**Minutes of the North Carolina Building Code Council
December 10, 2012
Raleigh, NC**

Part A – Administrative Items

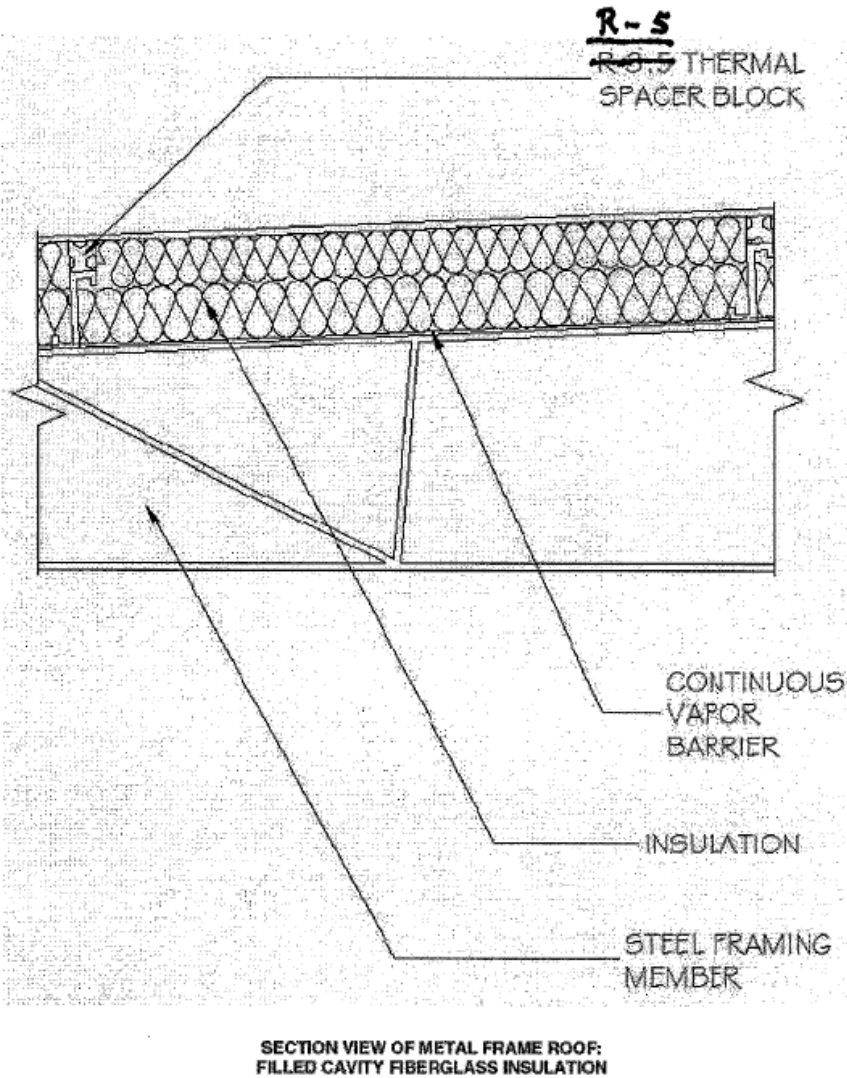
Item C – 2 Request by Daniel J. Walker, PE, with the Metal Building Manufacturers Association, to amend the 2012 NC Energy Code, Tables 502.1.2, 502.2(1), and 502.2(2), and Appendix 2.2. The proposed amendment is as follows:

ROOFS	DESCRIPTION
R- 11 10 + R-19 FC	Filled cavity fiberglass insulation. A continuous vapor barrier is installed below the purlins and uninterrupted by framing members. Both layers of uncompressed, unfaced fiberglass insulation rest on top of the vapor barrier and are installed parallel, between the purlins. A minimum R- 3 5 thermal spacer block is placed above the purlin/batt, and the roof deck is secured to the purlins. Drawings of typical details are shown in Appendix 2.2.

Revise Appendix 2.2 as follows:
